**RE: VICTORVILLE 2 HYBRID POWER PROJECT (07-AFC-1)
SUPPLEMENTARY RESPONSES TO DATA REQUESTS 37 AND 85 FROM DATA REQUEST SET 1, (1-110)**

**VICTORVILLE 2 HYBRID POWER PROJECT (07-AFC-01)
CEC STAFF DATA REQUEST NUMBER 37**

**VICTORVILLE 2 HYBRID POWER PROJECT (07-AFC-01)
CEC STAFF DATA REQUEST NUMBER 85**

Figure 1
 Survey Results Map
 Victorville 2
 San Bernardino County, CA

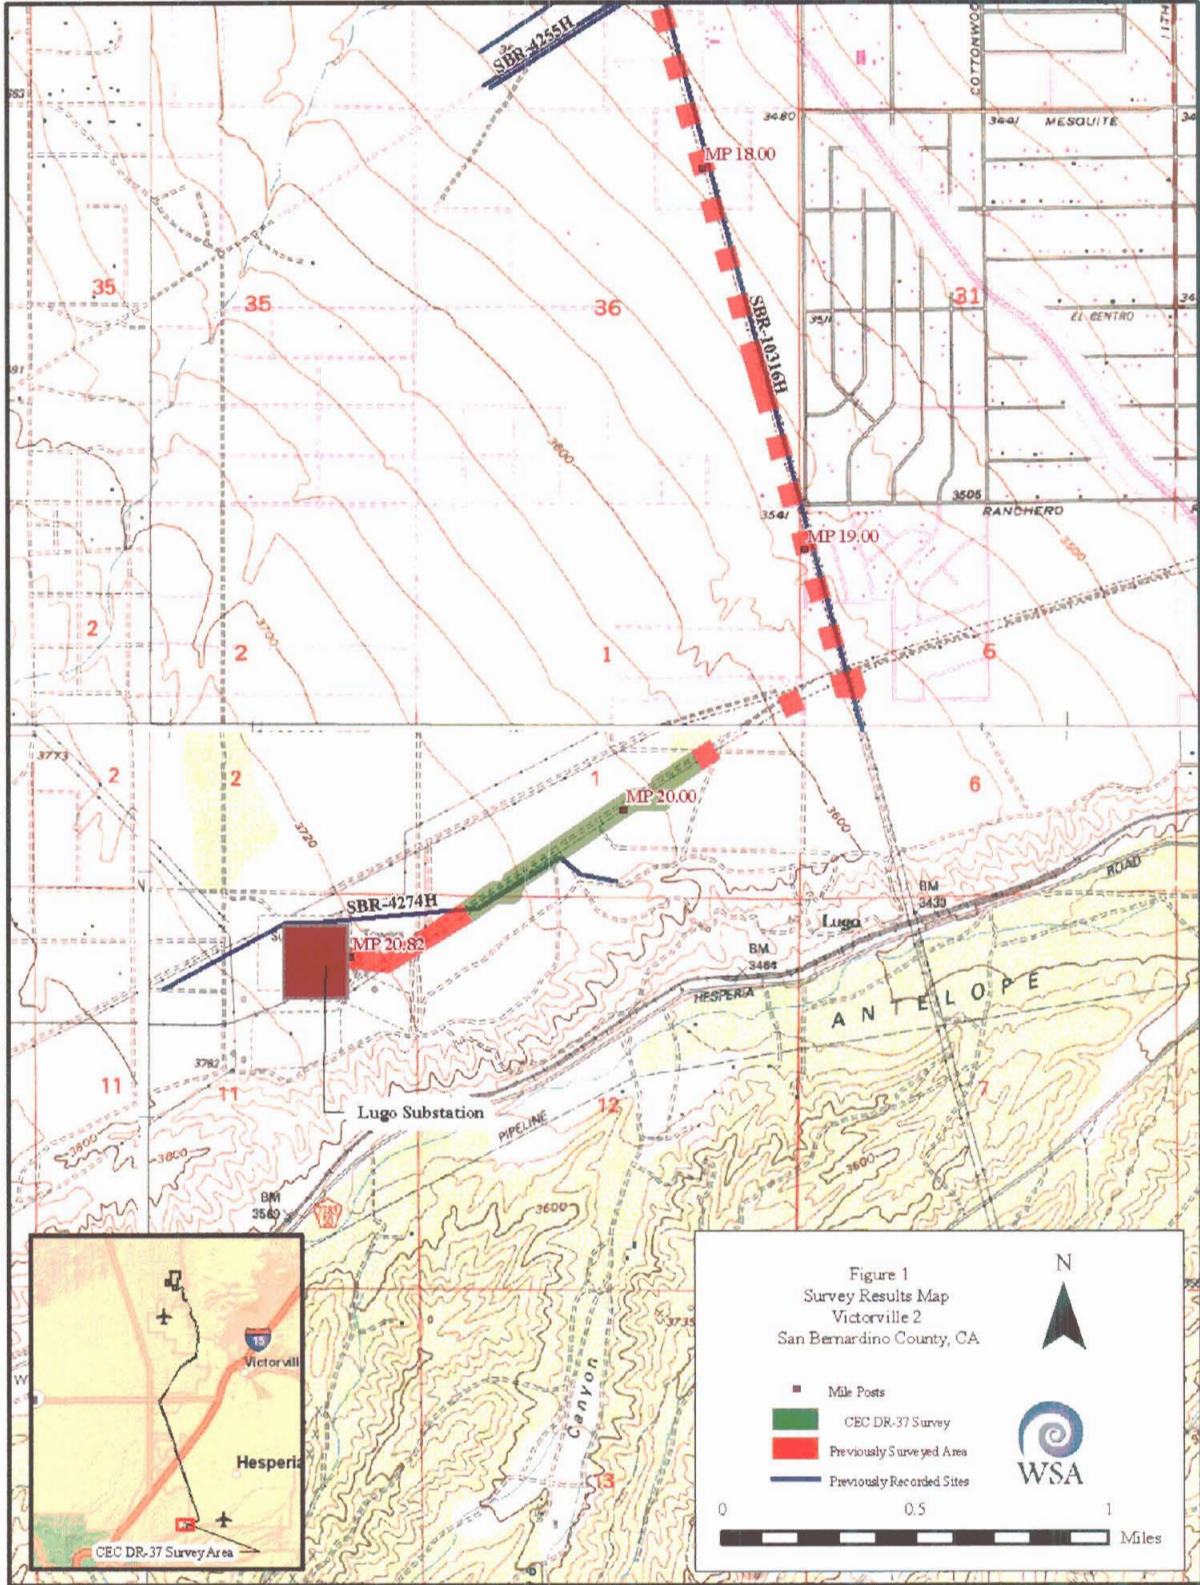
Data Request (DR) 37 requested the VV2 Project Applicant to explain why an approximately 0.75-mile-long stretch of transmission line Segment 3, east of Lugo Substation, was not surveyed. It also requested that the Applicant identify the unlabelled historic linear cultural resource shown on Figure 5 paralleling the proposed transmission line for about half the length of the unsurveyed stretch.

On September 28, 2007, William Self Associates (WSA) archaeologists Dr. Allen Estes and David Buckley conducted a survey of the 0.75-mile-long stretch of VV2 Project transmission line Segment 3, east of the Lugo Substation (Figure 1). The survey area included the 100 ft. ROW and a 100 ft. buffer on either side. An intensive field reconnaissance was conducted within the survey area. The two-person field crew maintained a maximum transect interval of 20 m. No ground disturbance (shovel probes, test pits, etc.) occurred during the survey, and no cultural materials were collected. Digital photographs were taken of the survey area. Photographs include general views of the topography and vegetation density, and other relevant images. The corridor was centered 125 ft. from the center line of the existing 220 kV Lugo to Kramer line. UTM coordinates of the approximately 0.75-mile-long corridor are 3803635.8N/467723.3E for the center of the northern end of the corridor and 3803026.8N/466764.7E for the center of the southern end.

Attempts were made to locate CA-SBR-4274H, a previously recorded linear resource that is recorded as crossing the survey area (see Figure 1). The recorded alignment of CA-SBR-4274H (a historic road) appears to follow the alignment of the transmission line access road in the survey area, which is regularly maintained and used (Refer to Photos 1-2). There is nothing characteristically historic regarding the access road, which is used primarily by transmission line maintenance crews and inspectors. No other roads were observed in the survey area with the same southwest-northeast orientation that is recorded for the historic road. Along with access road usage, modern residential development along the transmission

road alignment and construction of the Lugo Substation appear to have removed any trace of the historic road.

Revised Project Access Route from Air Expressway

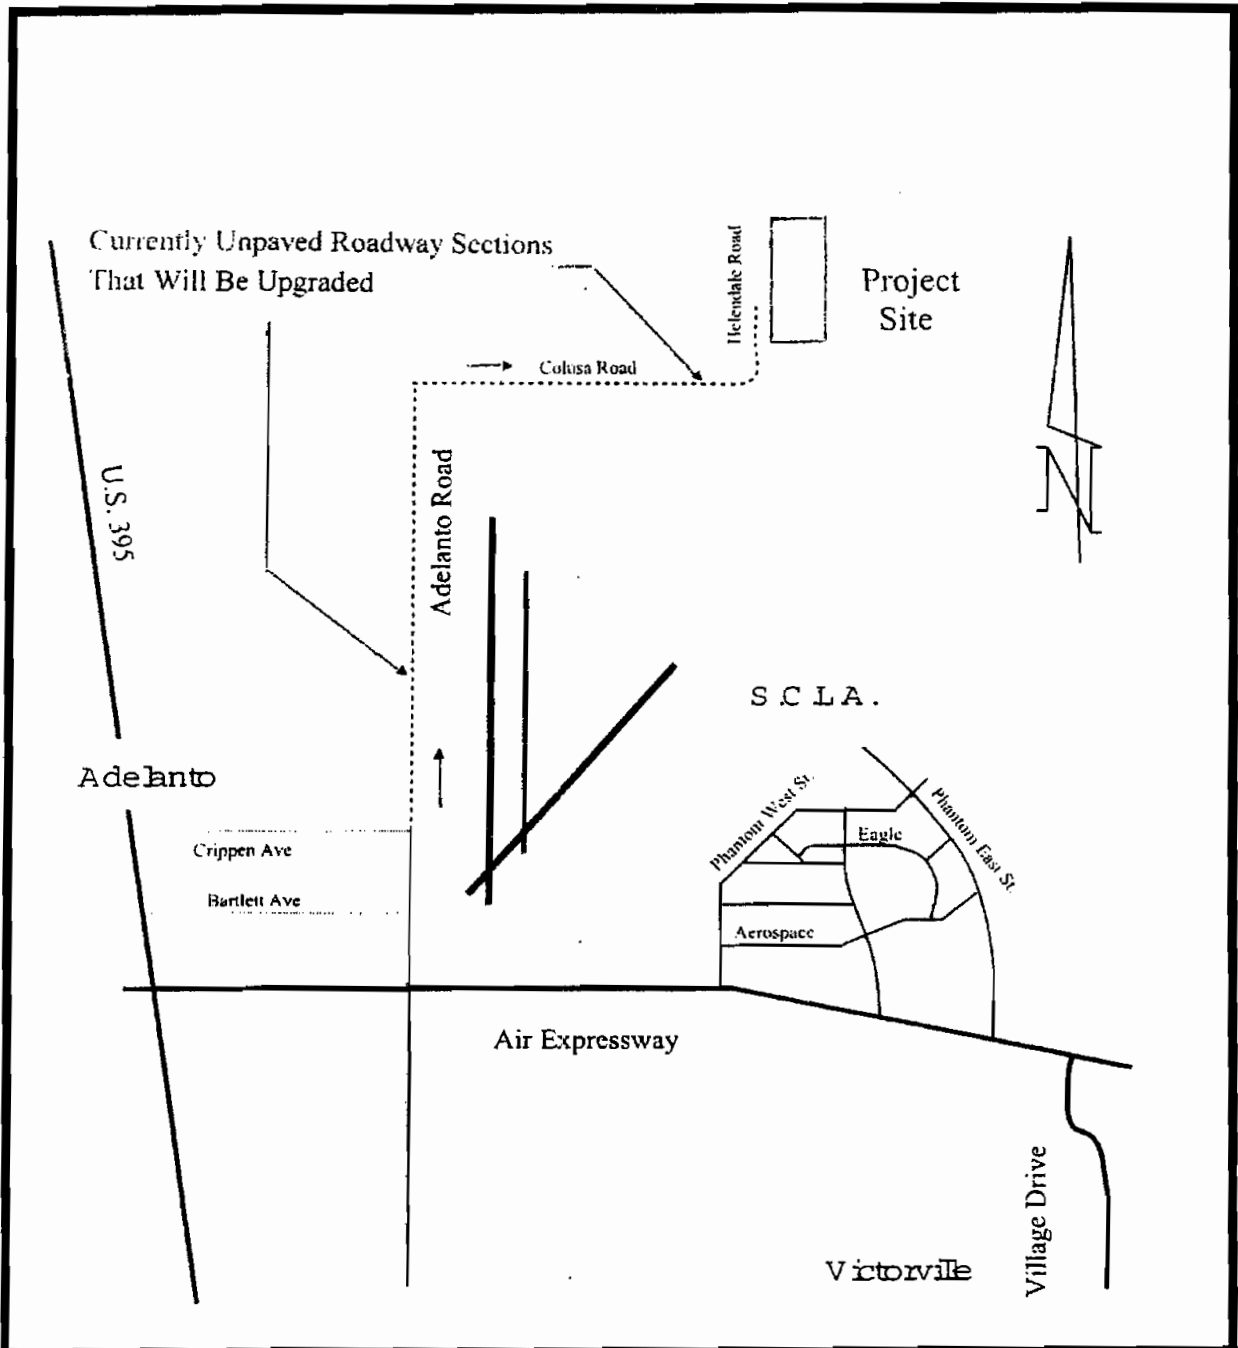
The following pages assess the potential traffic and transportation related impacts associated with modifying the proposed VV2 Project site access route from the route presented in the AFC. The AFC presented the proposed site access route as extending north from Air Expressway through SCLA via Phantom Street and a planned extension of Perimeter Road. The Perimeter Road extension would be permitted and constructed by the City of Victorville as part of overall improvements associated with development activities at SCLA. However, as noted in the response to CEC Data Request 85 submitted on July 23, 2007, the City's plans to extend Perimeter Road may be delayed and thus, the VV2 Project now plans to use existing roads as the primary site access. As described in the response to Data Request 85, Project site access now will be via Adelanto Road (traveling north from Air Expressway to Colusa Road), and then east on Colusa Road to Helendale Road and then north on Helendale Road a short distance to the site entrance (See Figure DR85-1). The following pages provide the additional traffic analysis that was identified as in preparation at the time of the July 23 submittal. The analysis is provided (i.e., uses Table numbers) as a supplement to the response provided on July 23 to Data Request 85.

As shown in Figure DR85-1, the revised access route currently includes roadway segments that are unimproved and have dirt surfaces. Colusa Road is unpaved along the entire distance (approximately 1.5 miles) from the Adelanto Road intersection east to Helendale Road (it also is unpaved all the way west to U.S. 395). Adelanto Road is unpaved from north of Crippen Avenue to Colusa Road. Adelanto Road is improved with two paved lanes in each direction north of Air Expressway to Bartlett Avenue where it narrows to a single paved lane in each direction to Crippen Avenue. Access to the Project site using this route will require upgrading Colusa Road from Adelanto Road east to Helendale Road and Adelanto Road north of Crippen Avenue to Colusa Road. A short stretch of Helendale Road, which is also unimproved, will also be paved from the Colusa Road intersection northerly to the site entrance, a distance of a few hundred yards. For each of these roadway segments, it is expected that the upgrade will involve paving two 14-foot lanes with graded shoulders.
